World Forum for Harmonization of Vehicle Regulations**Working Party on Lighting and Light-Signalling****Eighty-eighth session**

Installation UN Regulations:**UN Regulation No. 48 (Installation of Lighting and Light-Signalling Devices)****Proposal for a Supplement to the 06, 07 and 08 series of amendments to UN Regulation No. 48****Submitted by the experts from the International Automotive Lighting and Light-Signalling Expert Group ***

Symbols and patterns for the use as Driver Assistance Projections and Explanations of the Warnings/Highlights

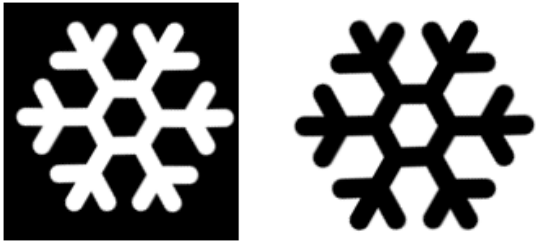
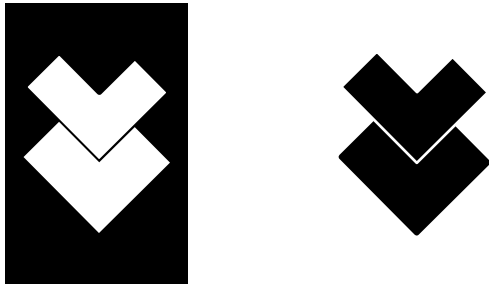
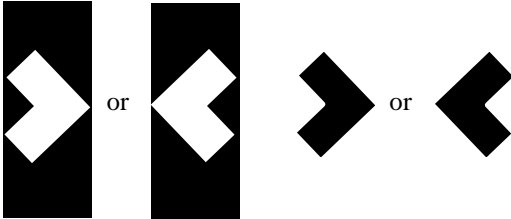
<i>Symbols and Pattern</i>	<i>Use case</i>	<i>Conditions and remarks</i>
	Slippery road warning	
	Risk of collision warning	Triggered when the relative speed is larger than 30 km/h and Risk of Collision Time is less than 1.4 s. Flashing at 4.0 hz +/- 1.0 hz allowed.
	Wrong way warning	Activated when the vehicle is entering a one-way road or a highway in opposite direction. Flashing at 4.0 hz +/- 1.0 hz allowed.
	Lane keeping assist warning	Activated if the vehicle unintentionally exits its lane.
	Predicted trajectory	May be transforming according to the predicted trajectory of the vehicle. Shall not flash
